Drilling/Casing Change

SUNDRY NOTICES AND REPORTS ON WELLS

Energen Resources would like to request the following changes to the Richardson #200.

Richardson Navajo 27-13 02 #4H

WELL LOCATION AND ACREAGE DEDICATION PLAT

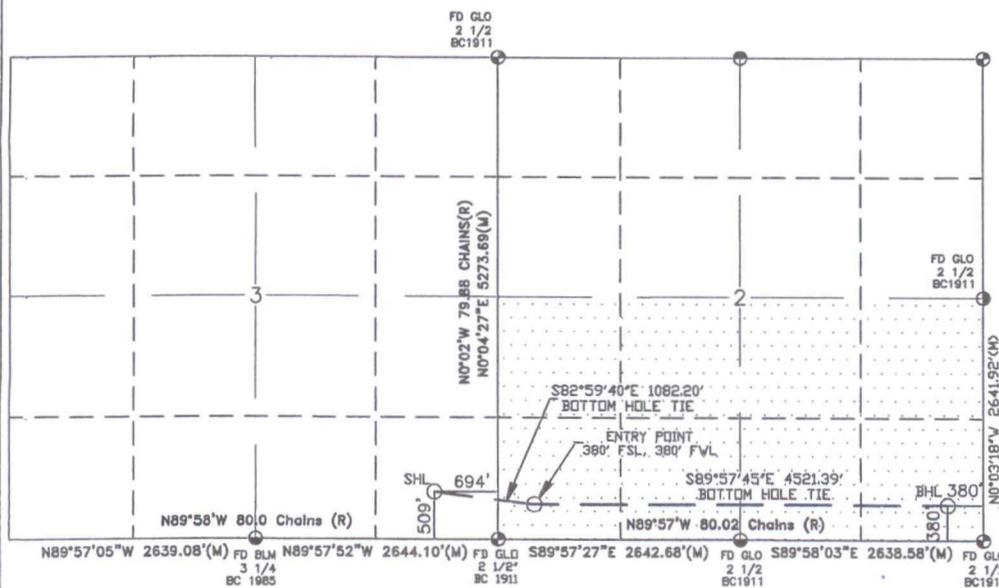
- * Change the name of the well from the Richardson #200 to the Richardson Navajo 27-13-2 #4H.
- * Change the target formation from the Basin Fruitland Coal (71629) to the Basin Mancos (97232).
- * Change the drilling plan from a vertical drill to a horizontal drill with the bottom hole at Sec 2 T27N R13W, 380' FSL 380' FEL (P) SE/SE as indicated on the attached C-102.

UL or lot no.	Section	Township	Range	Lot Idn	Feet from the	North/South line	Feet from the	East/West line	County
P	2	27-N	13-W		380'	SOUTH	380	EAST	SAN JUAN

Plan #1

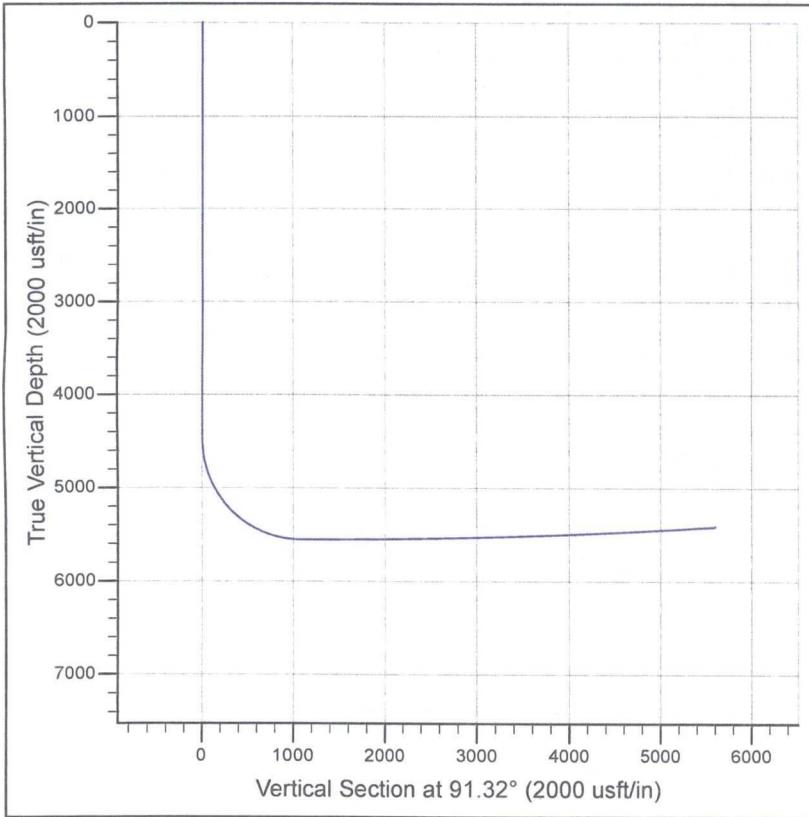
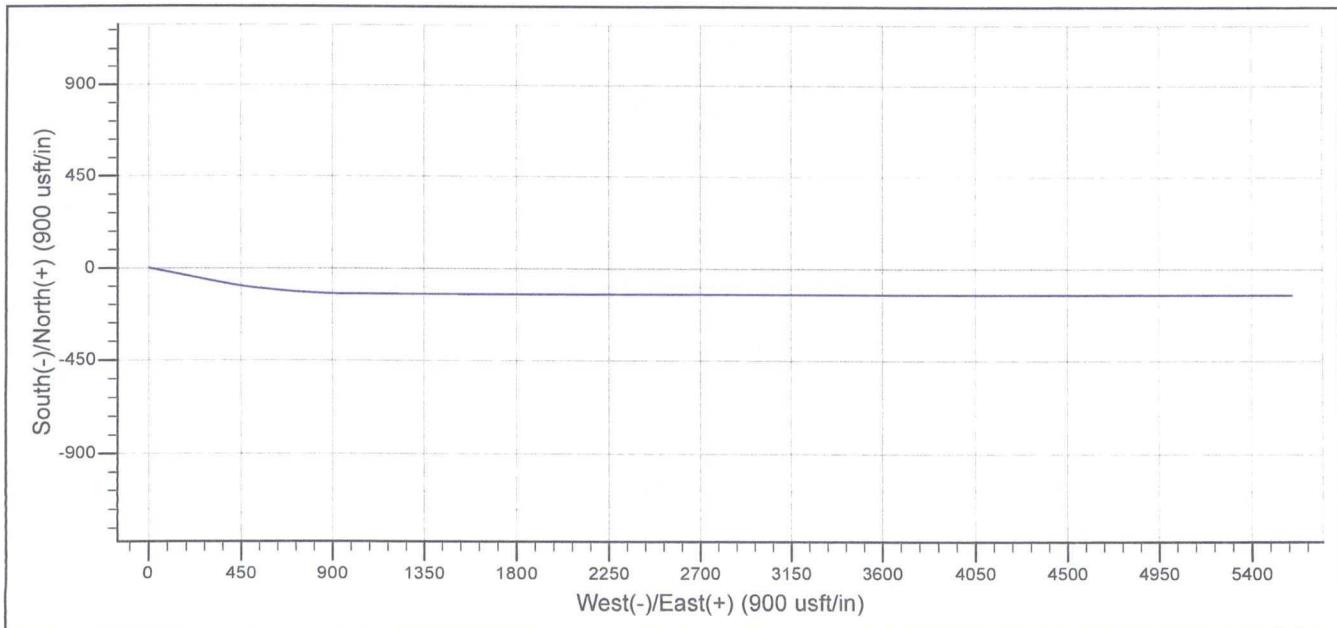
The new drilling plans depicting the casing changes along with the directional design is attached showing the revisions.
